**NOTICE OF DECISION**

**Concept Design Review – New 3- to 6-story, 254,152 square-foot mixed use development  
740-790 E. Green Street  
Case #: DHP2022-00248**

**ATTACHMENT A:  
CONDITIONS OF APPROVAL  
740-790 EAST GREEN STREET  
CONCEPT DESIGN REVIEW**

① Roof Appurtenance Exception  
 1" = 40'-0"

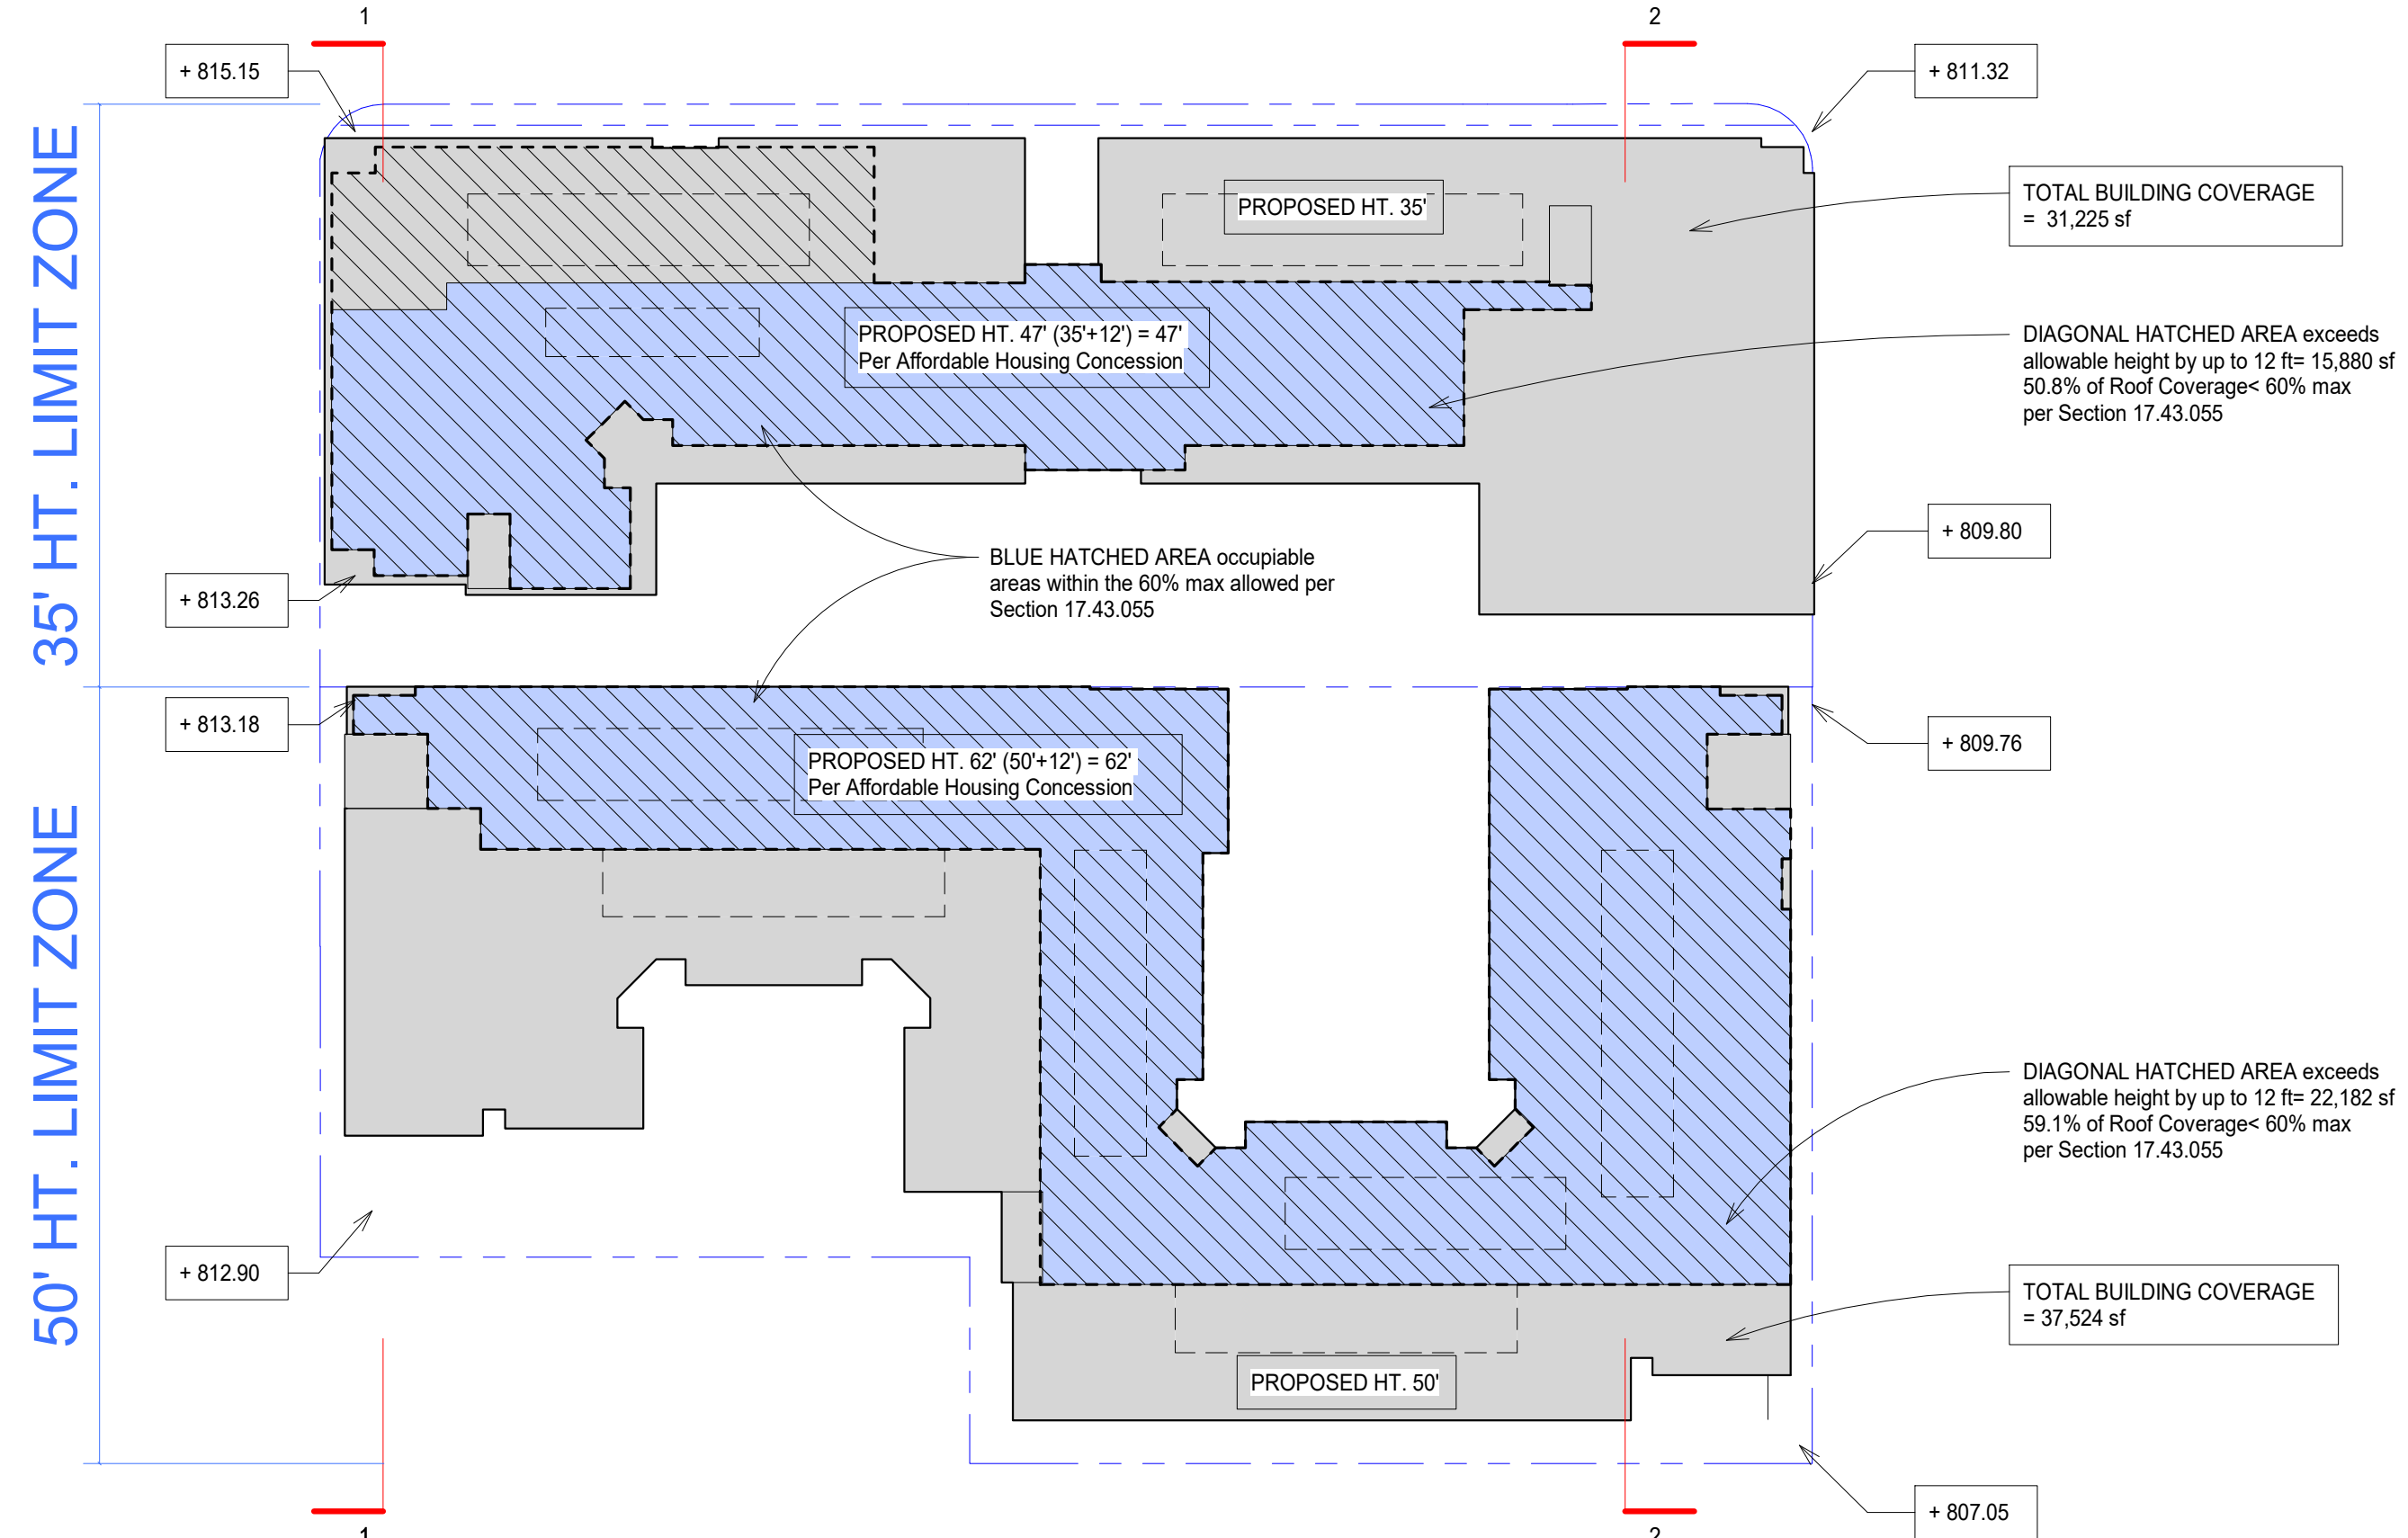
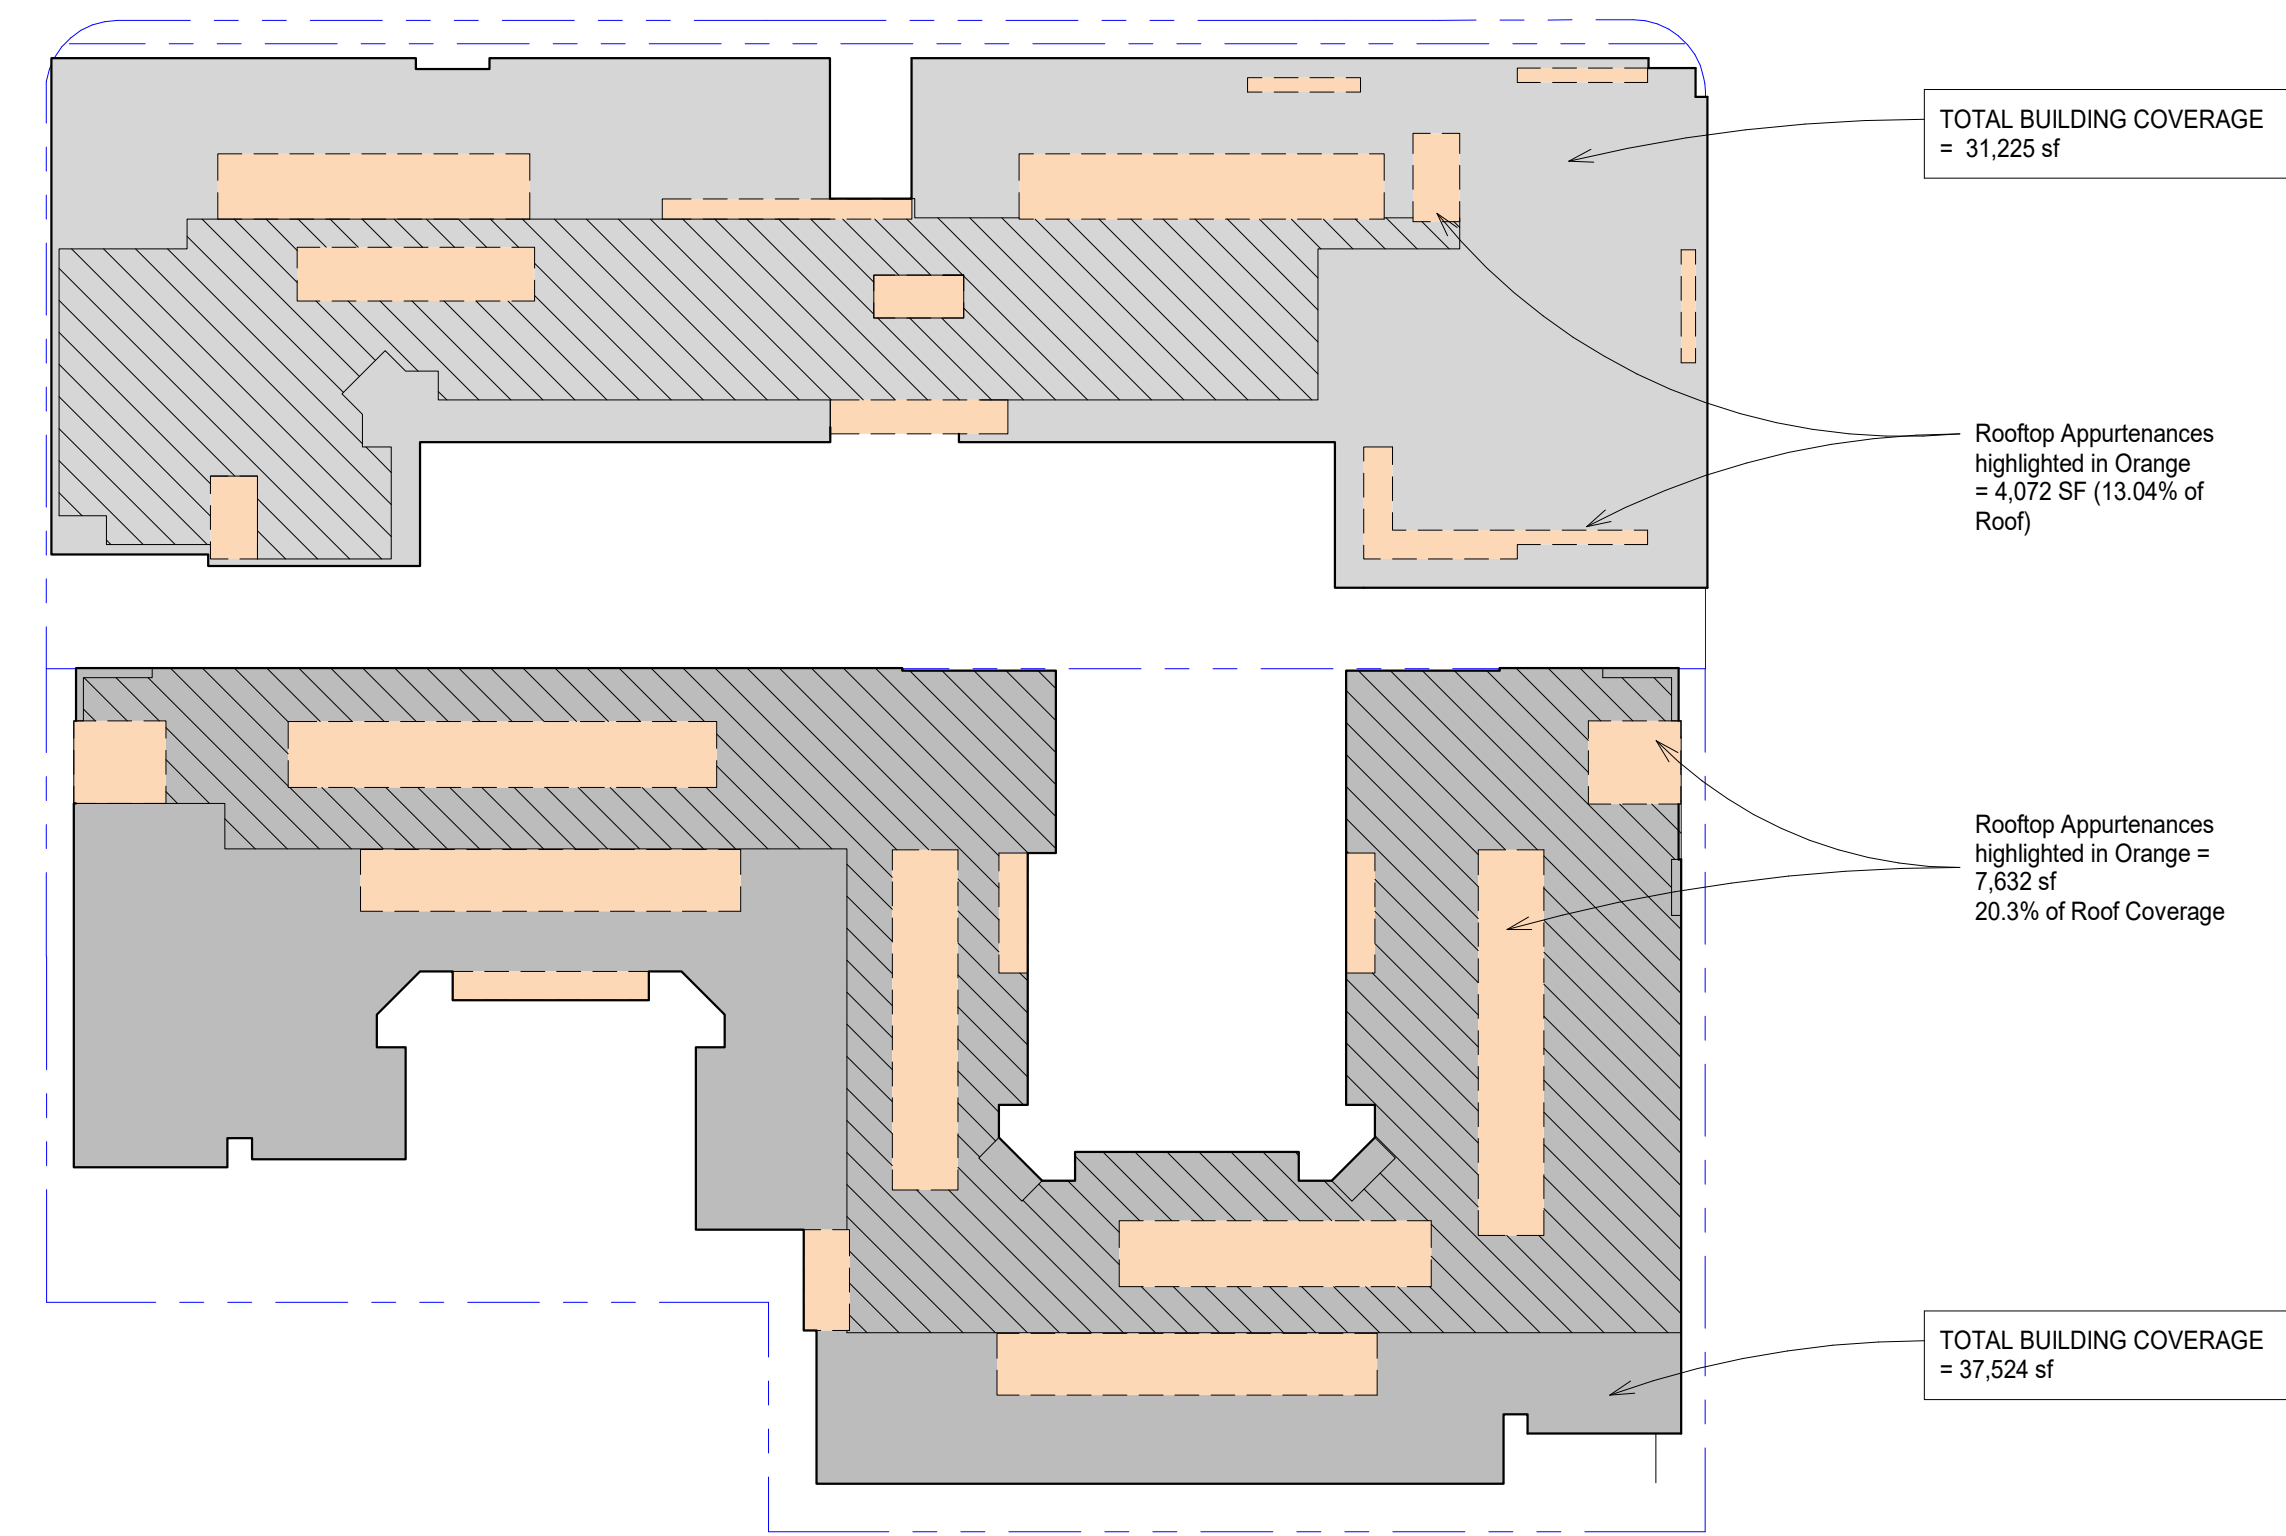
- i. Area calculations provided for the height analysis and roof appurtenance exceptions on sheet A003-2 provide different square-footages for the proposed roof area. The rooftop area used in the appurtenance calculation actually includes all roof areas, including lower roofs. Please adjust this calculation. *Proposal will comply, but needs to be consistent.*
- ii. Correct the referenced required heights in Sections 1 and 2 on Sheet A003-3. The sections go through both the 35- and 50-foot height limit areas and incorrectly shows each section as having one height limit area.
